Notice of Allowability	Application No.	Applicant(s)	
	10/509,171	GRAY, CHRISTOPHER	
	Examiner Christopher Verdier	Art Unit 3745

EXAMINER'S AMENDMENT

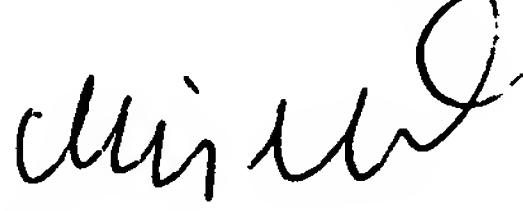
In figure 5, elements 4a and 4b may be provided with plural generally shaped apertures adjacent to each end wall near the gap 11.

Claim 15 has been canceled because it is directed to the embodiment of the rib having a lip-shaped cross section to engage confronting ends of the first and second impingement tube portion, which is excluded by the embodiment recited in claim 14 of the rib having a chevron-shaped cross section to engage the confronting ends of the first and second impingement tube portions with the confronting ends of the impingement tube portions being beveled in a complementary way to the chevron-shaped rib. Claims 18-20 have been canceled in order to place the application in condition for allowance, because these claims do not define over Japanese Patent 61-49,102 and European Patent 990,771. The above change to the drawings has been approved in order to show the apertures provided in or adjacent to each end wall as recited in claim 17.

The following changes to the drawings have been approved by the examiner and agreed upon by applicant: In order to avoid abandonment of the application, applicant must make these agreed upon drawing changes.
